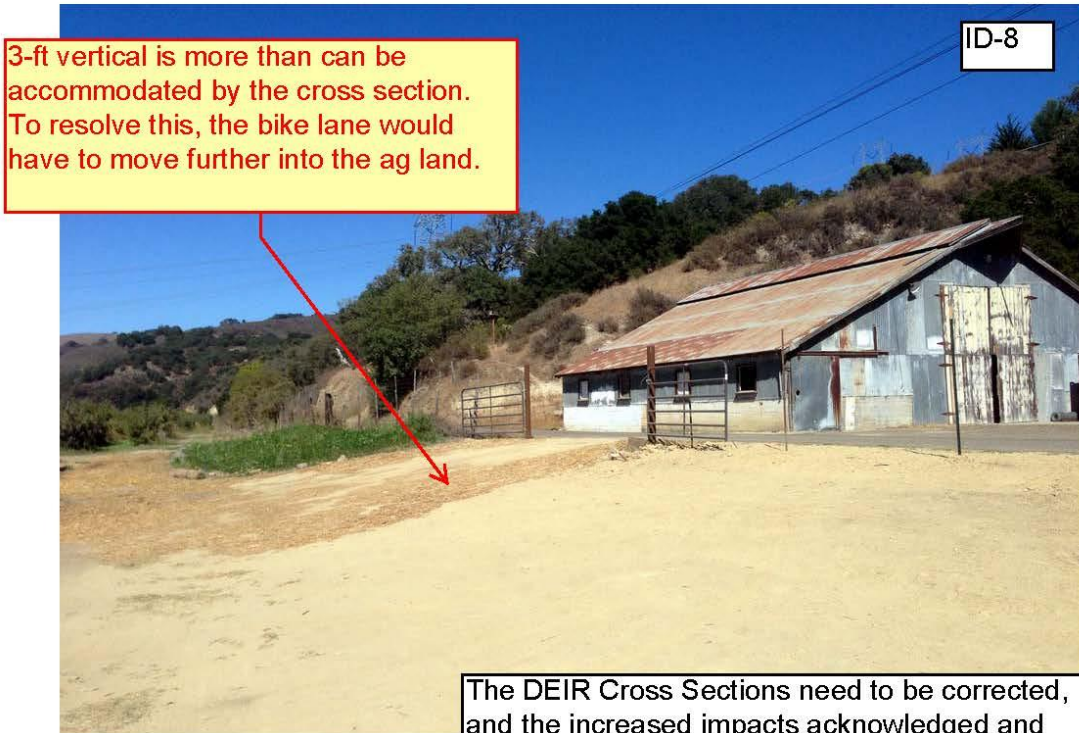
The DEIR needs to be revised to recognize and mitigate the impact of this ag use area.

See Master Response 1. The RDEIR provides an analysis of Alternative 6 (Farming Operations and Conflict Avoidance), which includes an alternative alignment that would avoid Monte Road and the adjacent farming operations, thereby avoiding potential conflicts with these uses. Alternative 6 has been identified as the environmentally superior alternative. Alternative 6 incorporates several alignment and design concepts as suggested in the Farm-Friendly Alternative.

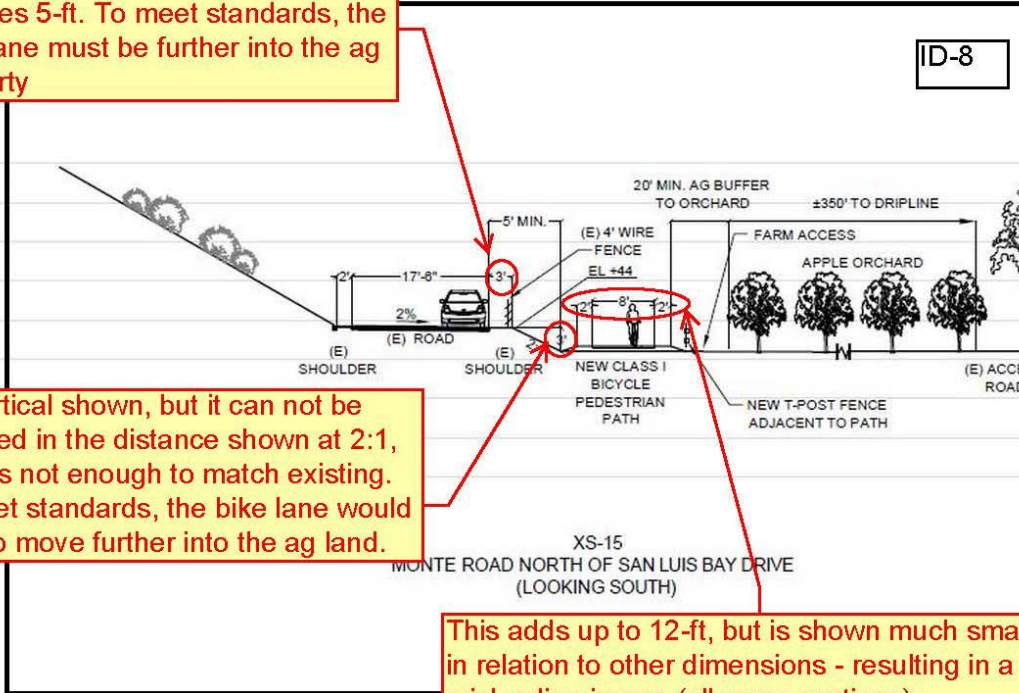
The DEIR Cross Sections need to be corrected, and the increased impacts acknowledged and mitigated

3-ft shown, but SLO Co std A1-b requires 5-ft. To meet standards, the bike lane must be further into the ag property

3-ft vertical shown, but it can not be achieved in the distance shown at 2:1, and it is not enough to match existing. To meet standards, the bike lane would have to move further into the ag land.

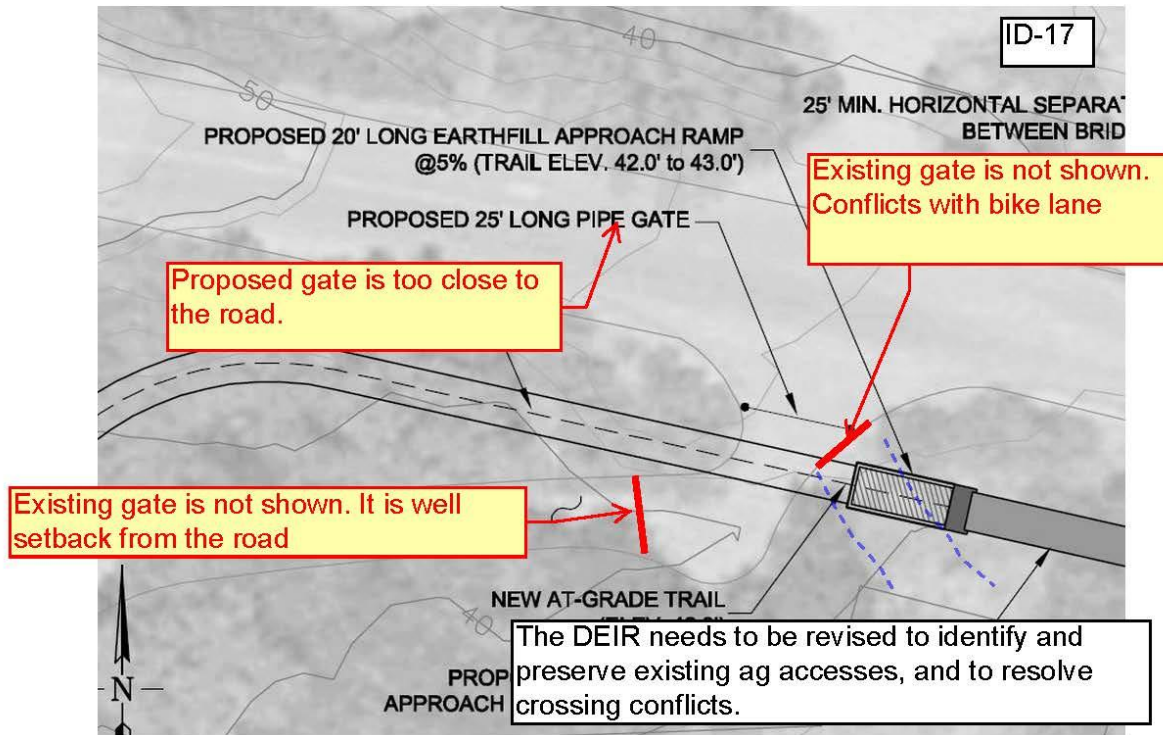
This adds up to 12-ft, but is shown much smaller in relation to other dimensions - resulting in a misleading image (all cross sections)
